This Addendum forms part of the Bid Documents and amends the Bid Documents as described below.

3. ARCHITECTURAL DETAILS - PROJECT MANUAL VOLUME 2

5. **ARCHITECTURAL DRAWINGS**

KEDRON EAST CATHOLIC ELEMENTARY SCHOOL
DURHAM CATHOLIC DISTRICT SCHOOL BOARD
Control Panel Elevation Detail

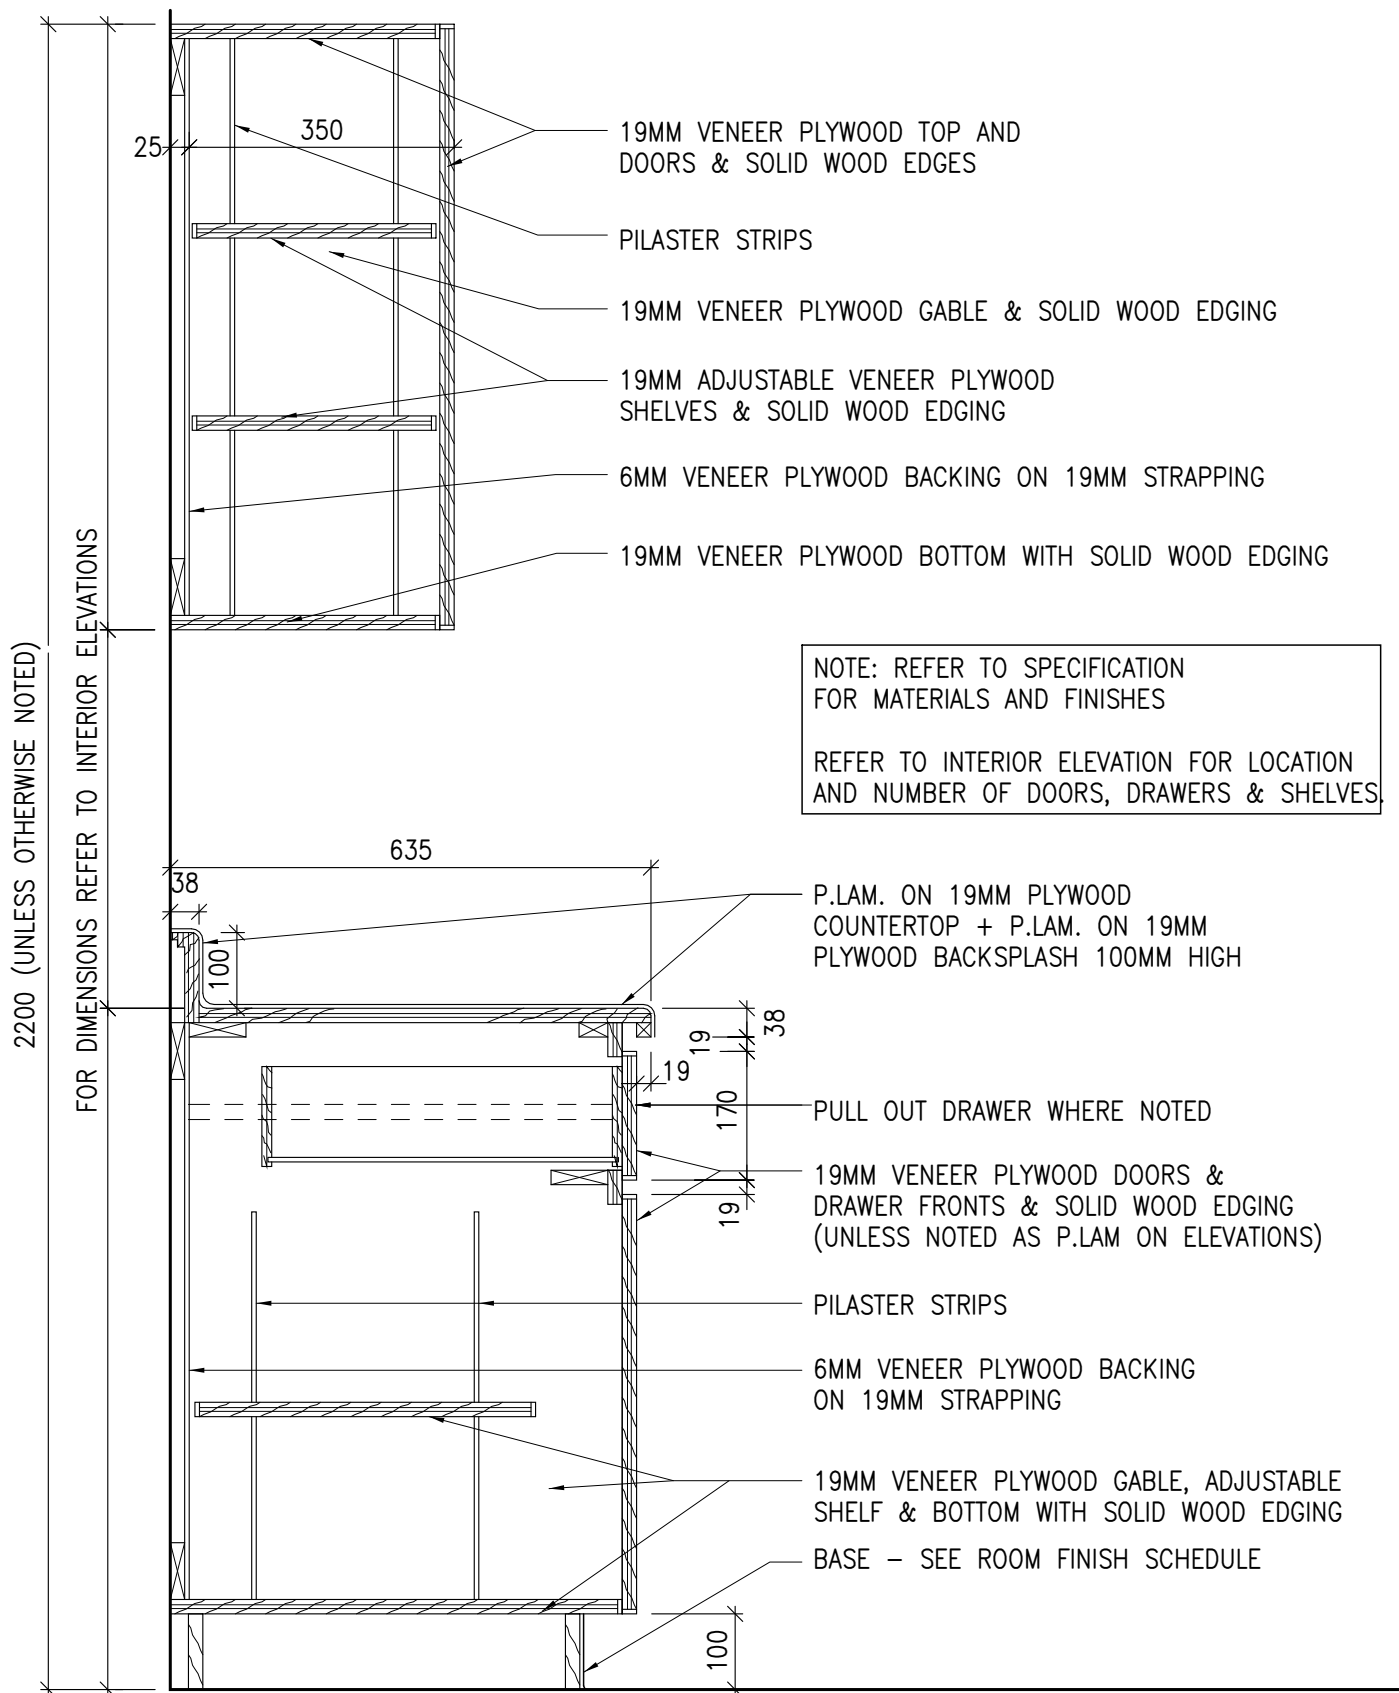
- .1 Remove one future computer hookup outlet, see attached revised detail D400.

Cupboard Detail - 3 Drawers

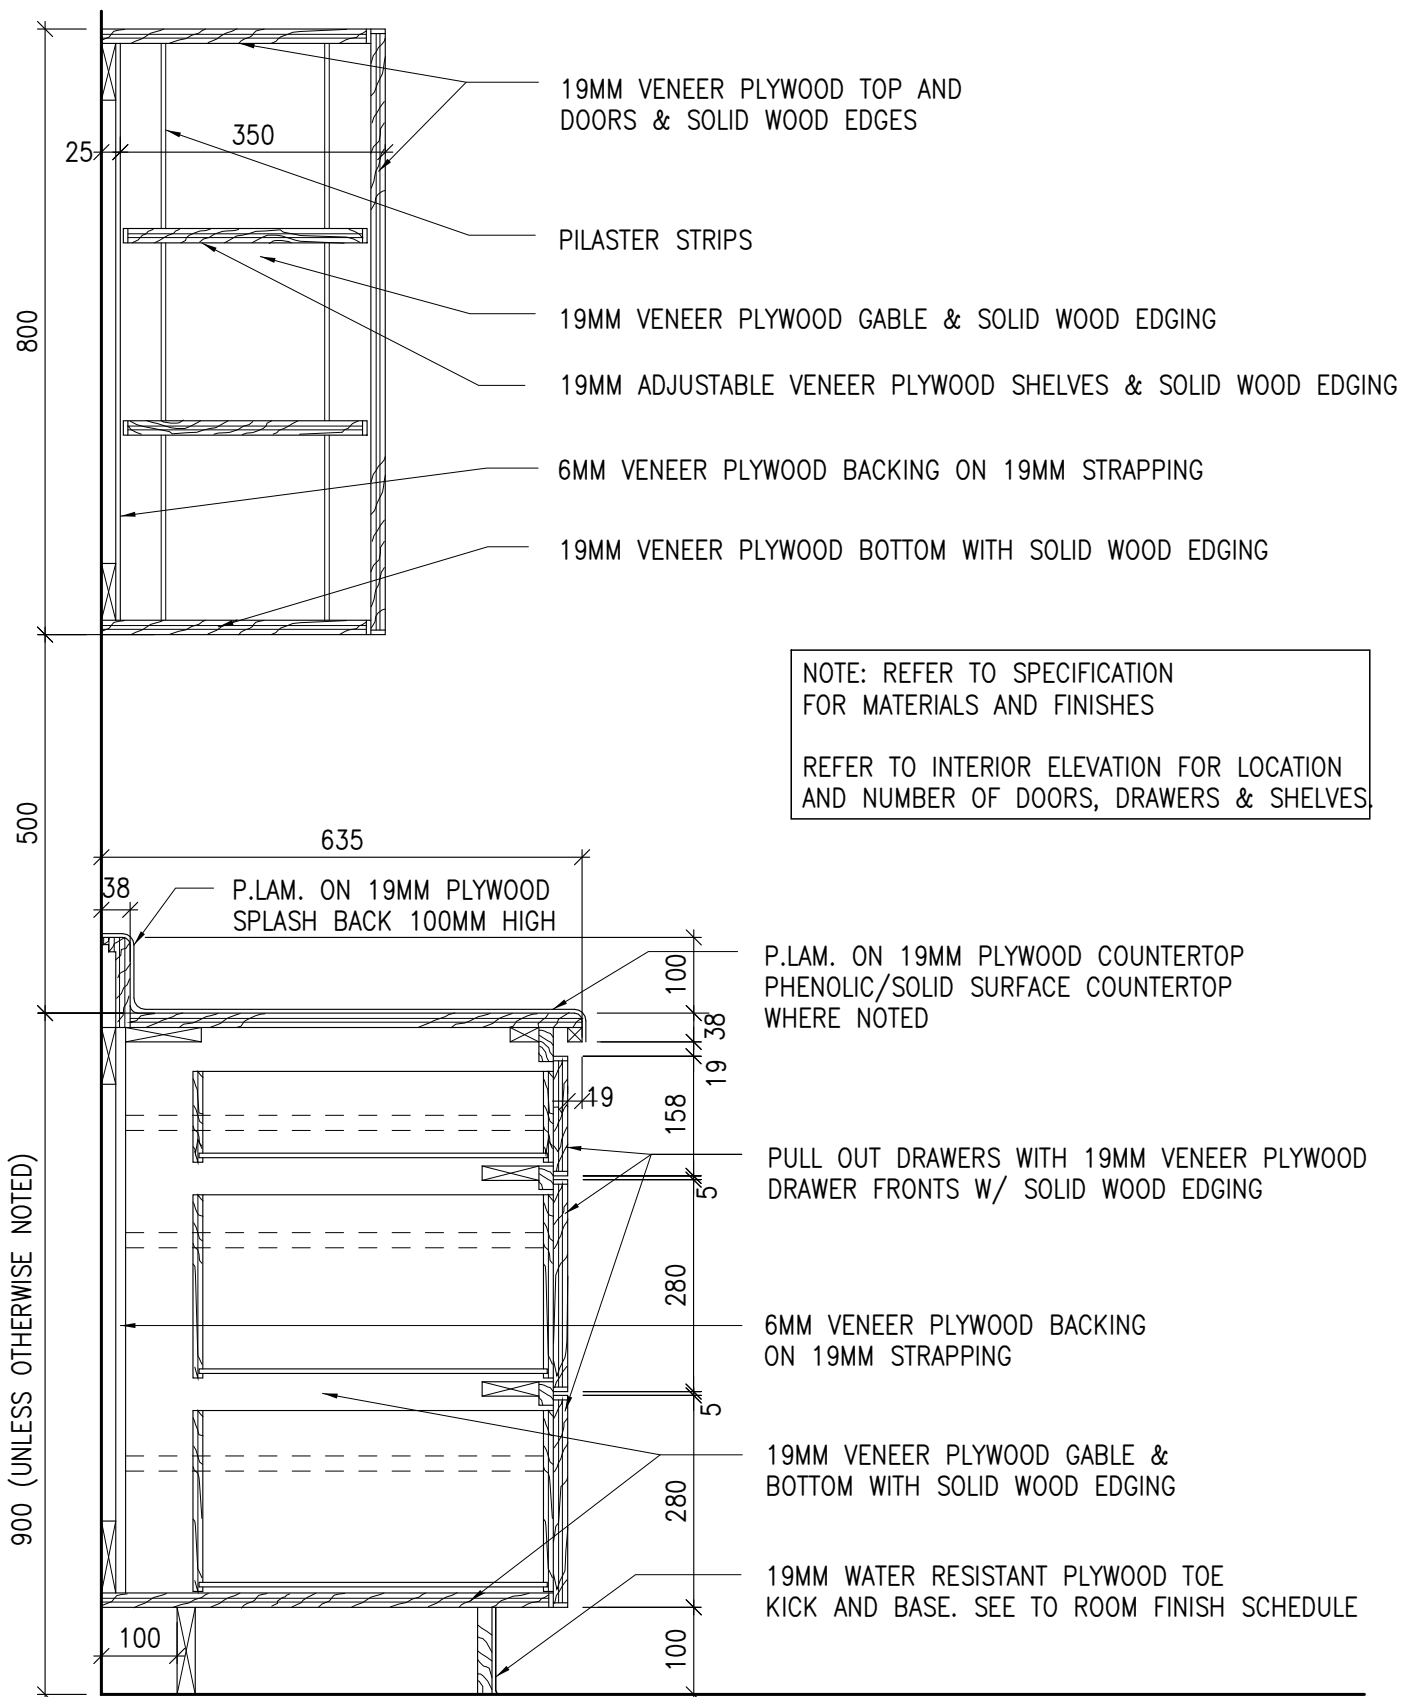
- .1 Remove references to “P.lam plywood” and replace with “Veneer plywood”, typical, see attached details.
- .2 Remove references to “P.lam edges” and replace with “Solid wood edges”, typical, see attached details.
